Access audit at Guild Hall, Walkden

Conducted on 23rd February 2015

Introduction: Access 2 All Areas were invited to conduct an audit at the Guild Hall, Walkden

Disable toilet

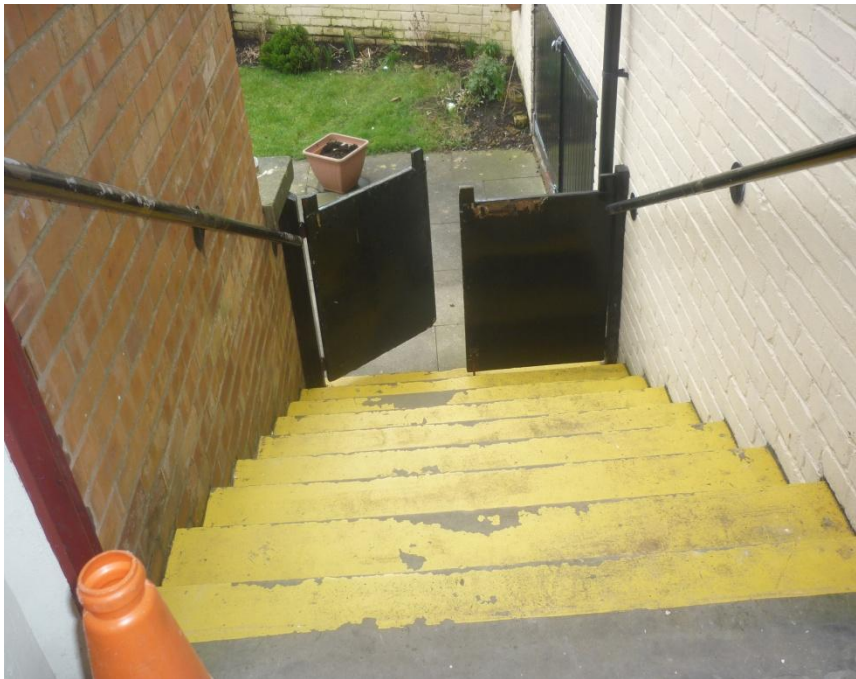
The disabled toilet was well equipped and Roy was able to access the facility without any problem.

Step to access cobbled road at the rear of the building

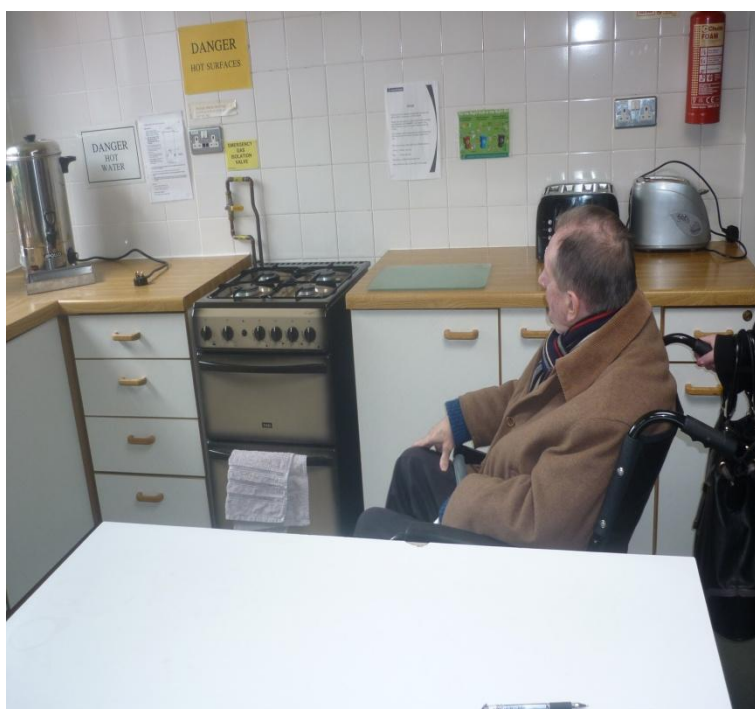
The fire exit was very problematic. The only means of exiting were down a steep flight of steps. In the event of a fire anyone with mobility issues would be in real difficulty. Even if someone were to get down the steep steps there were other steps to get down to reach the road at the back of the building.

1. The fire exit needs to be completely redesigned. This does not comply with the requirements of the Equality Act. We felt that the best (and most viable) alternative would be to re-site the fire exit to the main hall. This would still present some difficulties as there is no current means of exit. If a door and ramp could be installed (To the grassed area) this would mitigate the risk and provide wheelchair users with an exit if the front entrance were to be inaccessible due to fire.
